Re: Edgley Construction / Nelson, Brenda Res. / Pinemount Road Lake City, FL

This letter is in reference to inspection issues on the above referenced project.

RODS FOR UPLIFT - OPTIONAL

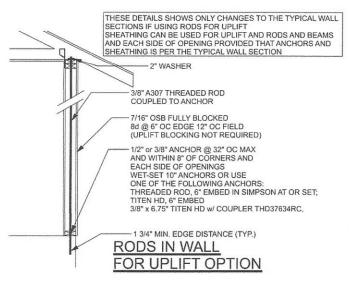
1. The engineering we provided only had the option for using straps beside the openings. The framer wanted the option for using threaded rods instead. Below are the details for the threaded rod option.

RODS AT OPENINGS FOR UPLIFT OPTION

RODS AT BEAM TO WALL FOR UPLIFT OPTION

- 3/8" THREADED RODS CAN BE USED AS THE UPLIFT CONNECTION
- IN PLACE OF USING THE SHEATHING FOR UPLIFT RODS ARE TO BE INSTALLED PER THE DETAILS ABOVE
- THE ROD LOCATIONS ARE TO BE AS SHOWN ON STRUCTURAL PLAN TYPICAL ROD PLACEMENT IS TO BE:
- 5'-4" OC MAX IN MAIN WALLS (FULL UPLIFT) 8'-0" OC MAX IN GABLE WALLS / JACK TRUSSES (LOW UPLIFT) EACH SIDE OF OPENINGS THAT REQUIRE UPLIFT STRAPPING
- EACH SIDE OF EACH CORNER AT BEAM TO WALL CONNECTIONS
